RP 45, RP 47, and RP 48

**NORTH DAKOTA DEPARTMENT OF TRANSPORTATION
BISMARCK, NORTH DAKOTA**

Principal Author:
Logan Beise P.E.
October 2015

SCOPING REPORT

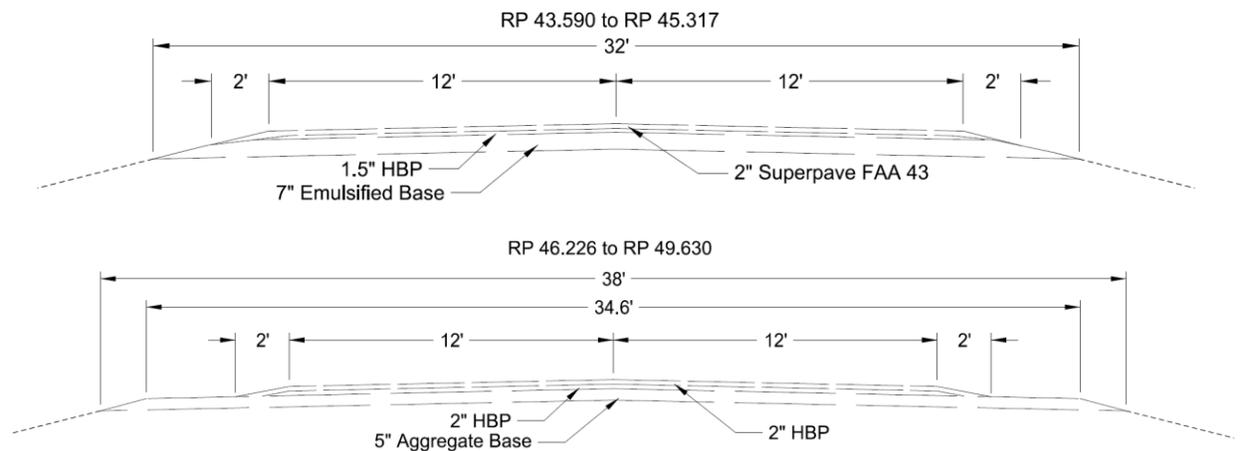
The grade raise completed on the north side has protected the embankment from the water. The south side does not have the big fetch but has seen the slope deteriorate to the point that work is required before the embankment starts cutting into the roadway. The pipe in this area is separated near the middle of the westbound driving lane. The pipe was extended on the north when the grade raise was done. Most likely due to the separation and the water level there is also a frost heave in the same area. Even though this project is not a New/Reconstruction Investment Strategy, the pipe should be replaced during this project, due to the separation and also since a subcut may also be done at this pipe location. A 6:1 slope on the south side should be looked at as well as the standard 10:1 to determine which will have less impact and material cost. Below is the grade raise in this area completed on the north side of the road.
